Florida Power & Light Distribution Forms and Figures

District 2 Utility Contact Form

| FPI: | 210447-5-52-01 SR16 St. Johns Co. Roadway Plan Sheets Dtd 8/5/24 Add Lanes/Reconstruct |

210447-5 FDOT Plan Sheets (Roadway - Dtd 8/5/24) 081224

| REVISIONS | | | | ENGINEER OF RECORD | | STATE OF FLORIDA DEPARTMENT OF TRANSPORTATION | | | ROADWAY PLAN | SHEET NO. SR 16 - PLAN |

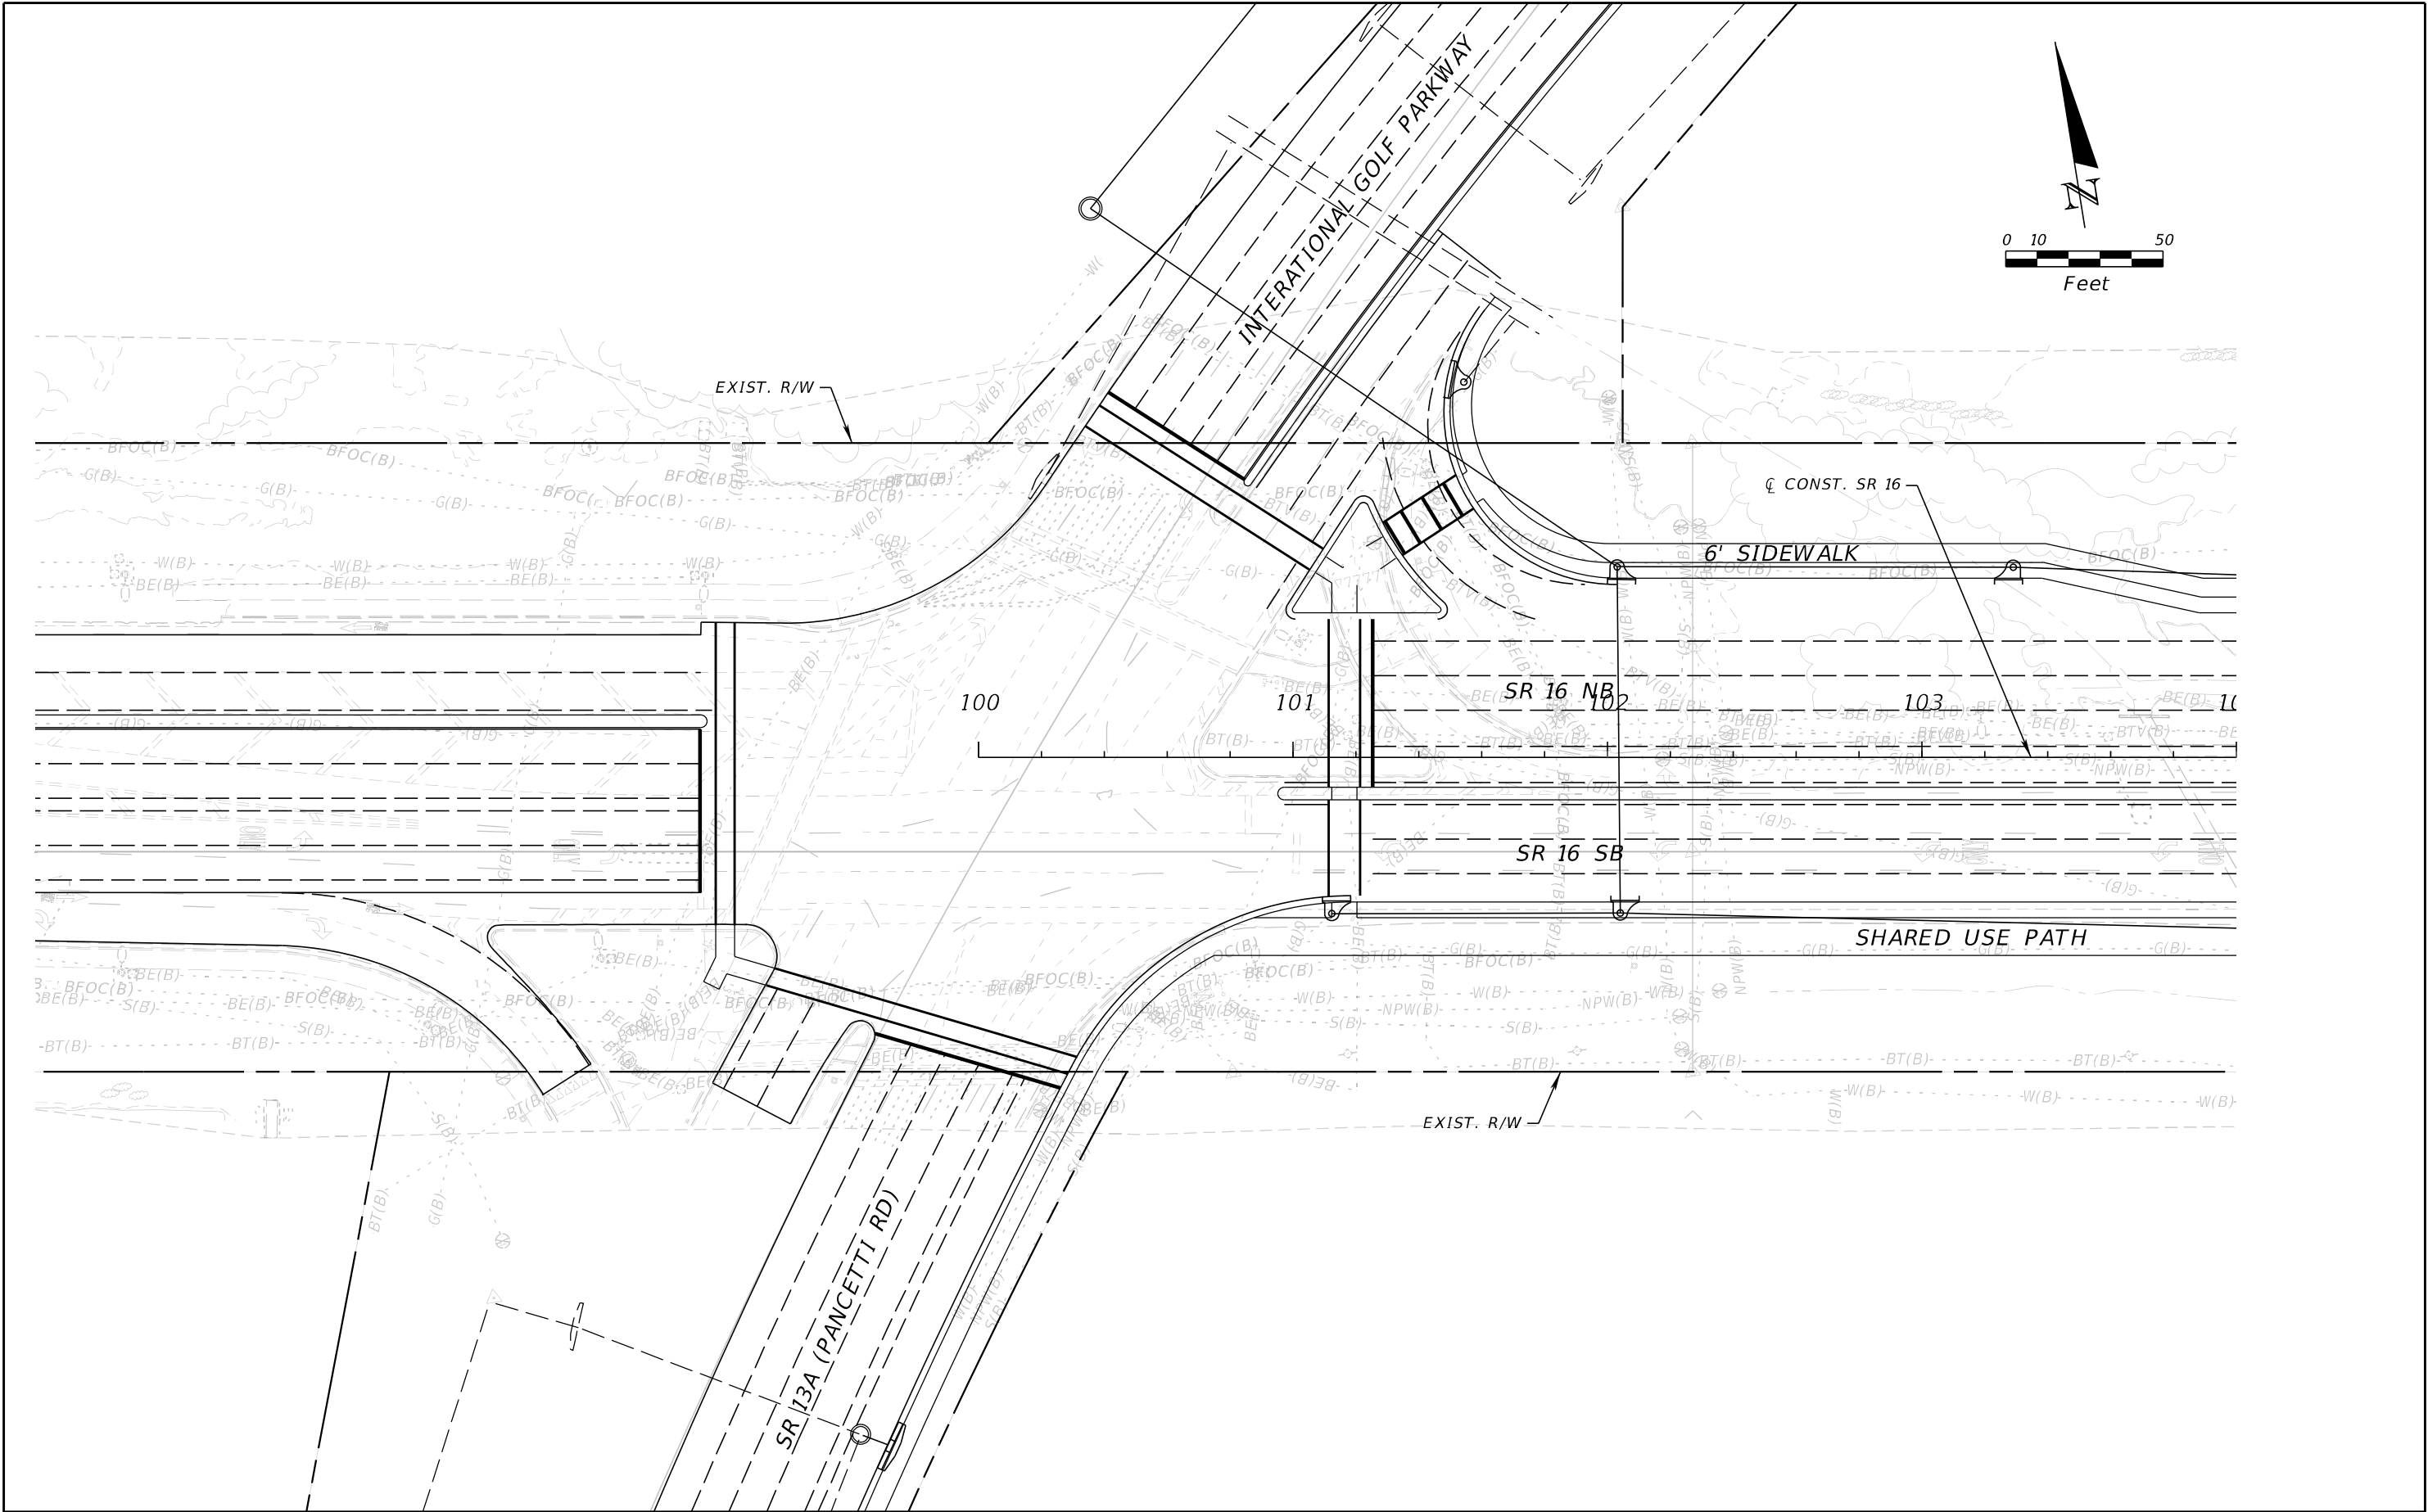
OE UTILITIES NOT MARKED ON PLANS.
FPL MARKUPS ARE ESTIMATED BASED ON
PLAN SHEETS AND FPL GIS. IF ANY
CONFLICTS, PROVIDE CONFLICT MATRIX
OR SHOW OE ON 30% PLANS.

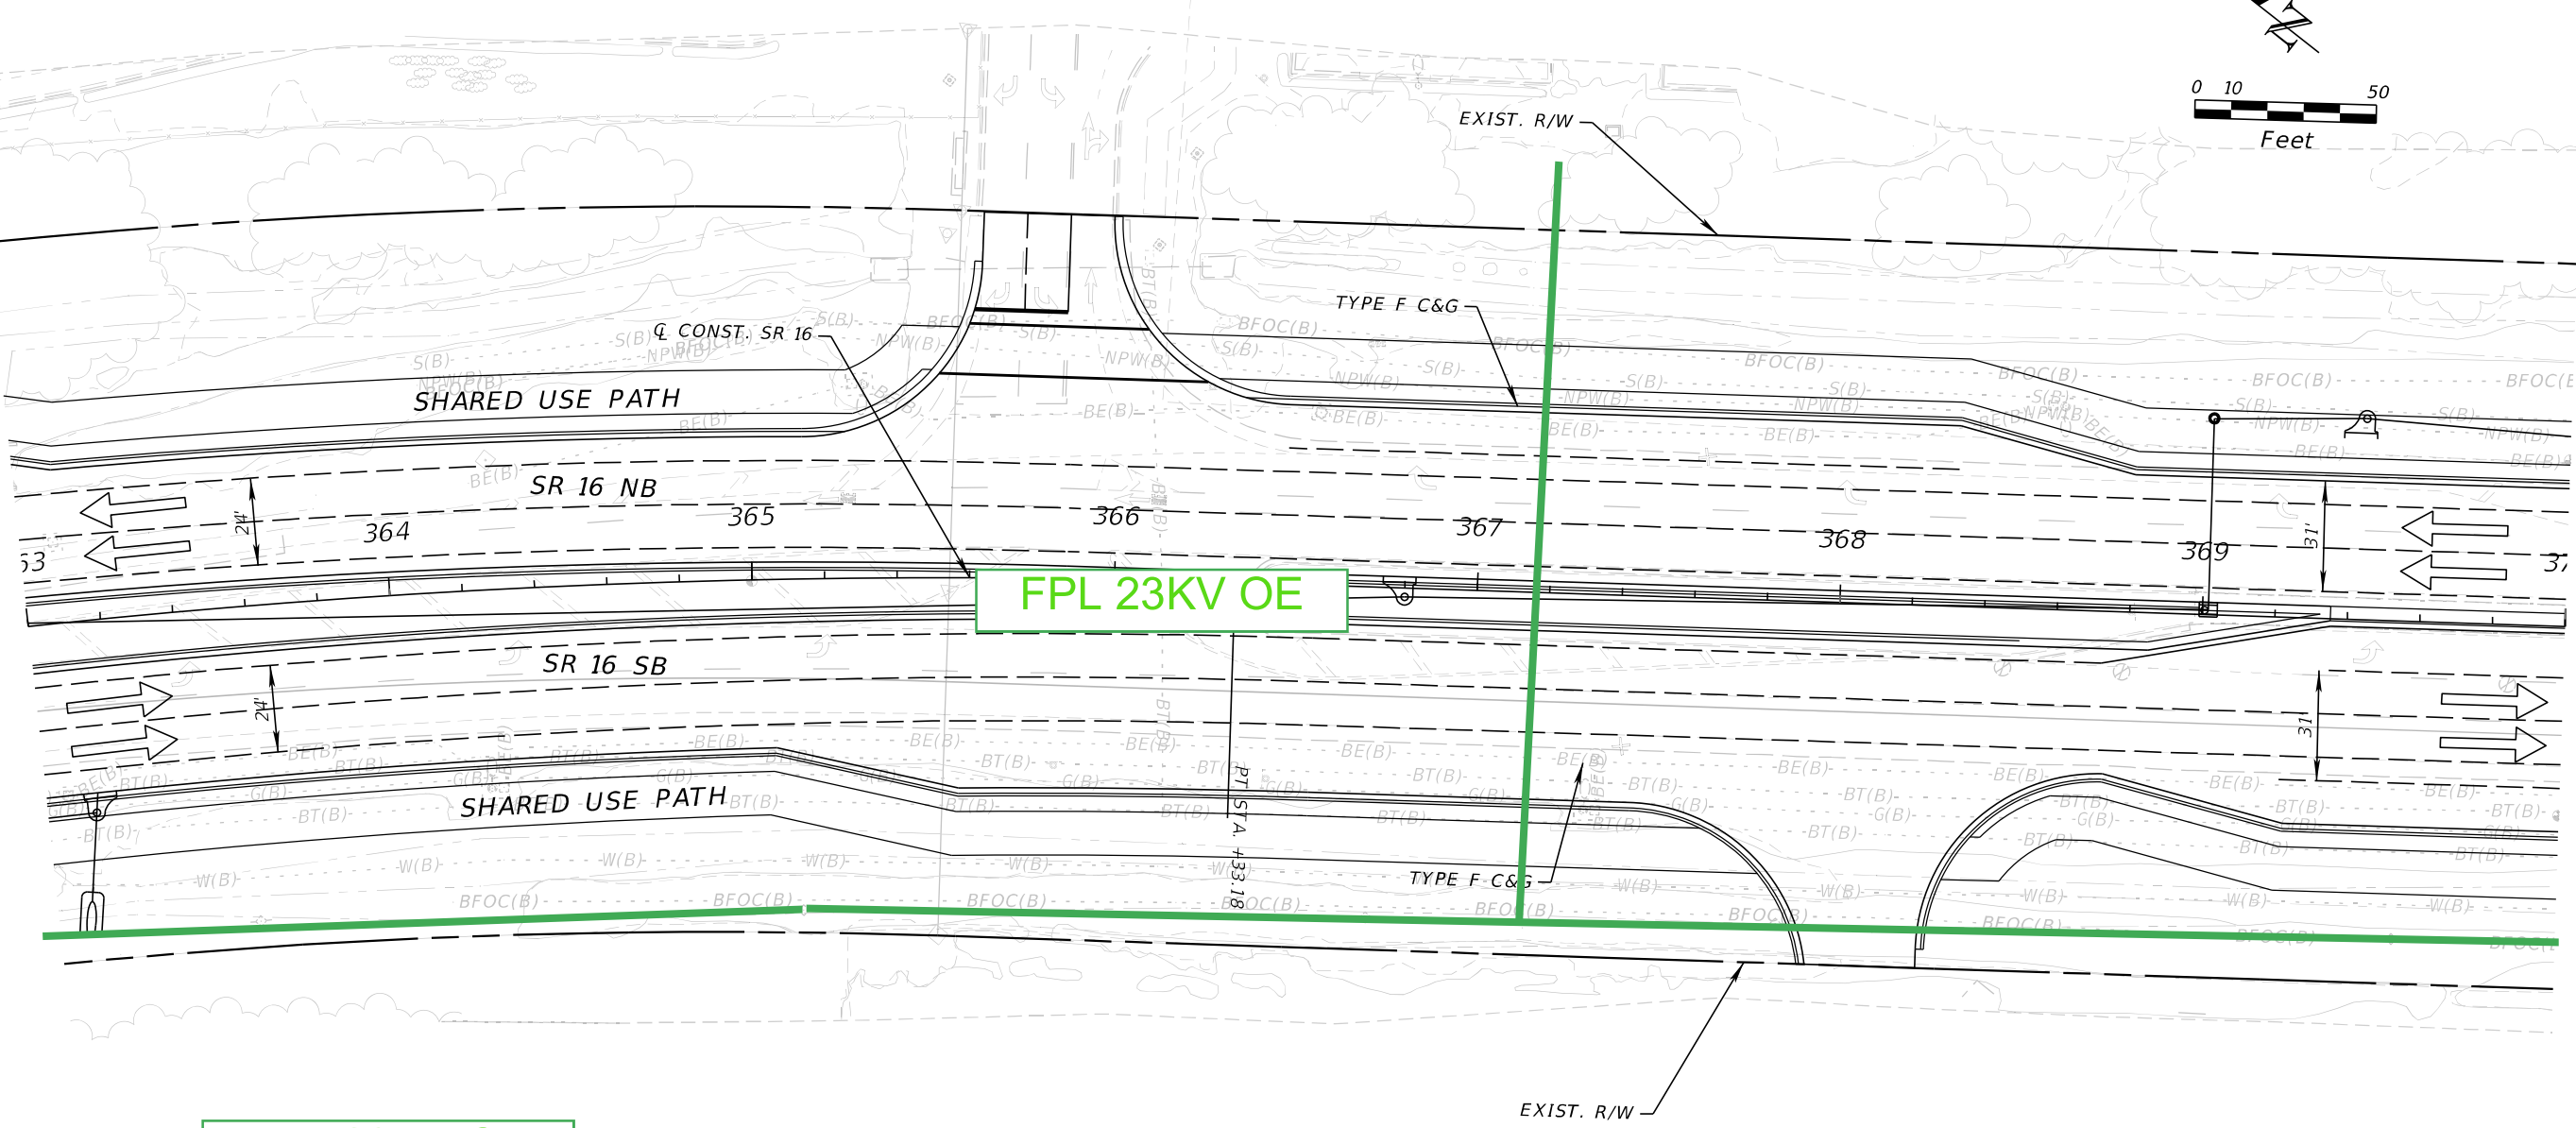
FPL 23KV OE
